PROJECT DESCRIPTION: Site Description

PROJECT DESCRIPTION: Proposal

FINDINGS: For Site Plan Review

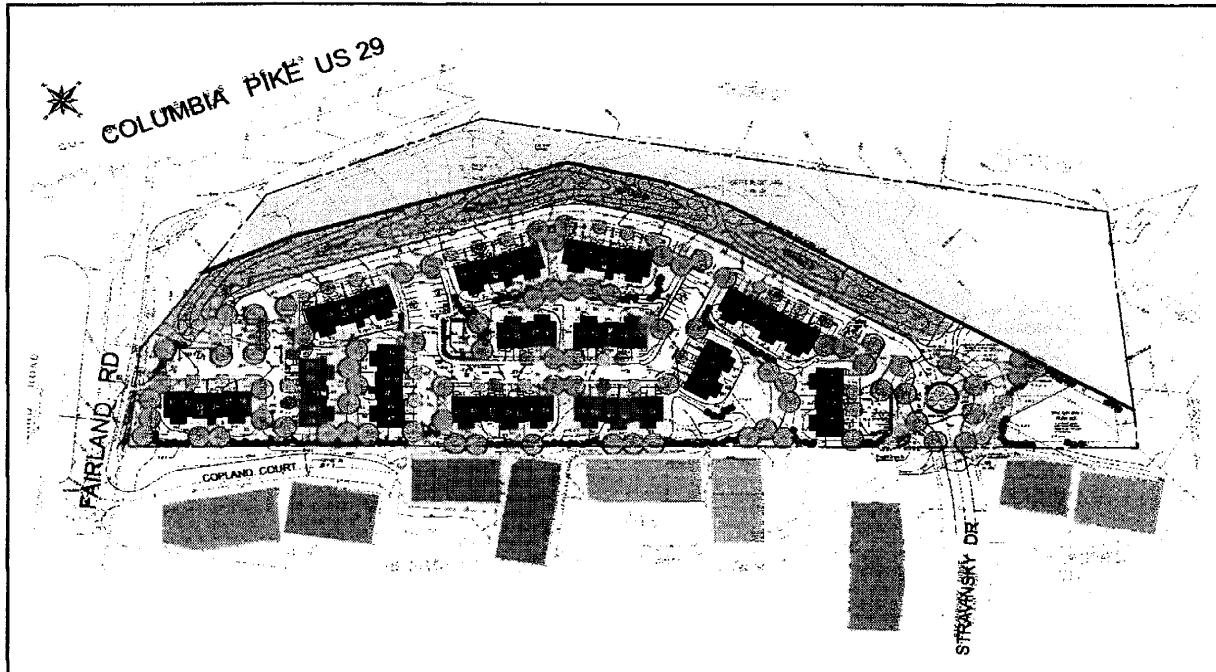
The Site Plan proposed for the Fairland View Property. Note the solid red line showing the alternate alignment for the SHA Intercounty Connector ROW (Corridor 2). The dark green strip adjacent to the ROW represents the landscaped berm for visual screening and noise attenuation. Staff recommends extension of the public sidewalk on Fairland Road and the addition of street trees.

Landscaping for the noise mitigation berm consists of 57,500 square feet of planting, including Red Maple, Tulip Poplar, White Pine, White Oak, Red Oak, Virburnum, and Arrowwood. Staff recommends further review of the berm for design dimensions, plant spacing and species, and noise mitigation effectiveness, prior to signature set. Design of the berm is crucial to achieving a satisfactory level of compatibility, visually, physically and acoustically with respect to the surrounding uses. [See also *Compatibility Finding*, below.]

Staff recommends a shift in the placement of the street trees to allow the trees to be planted within the curbside grass panel and the separation of the sidewalk from the vehicular travel lane.

Staff has included a condition of approval requiring further review of the berm prior to signature set.
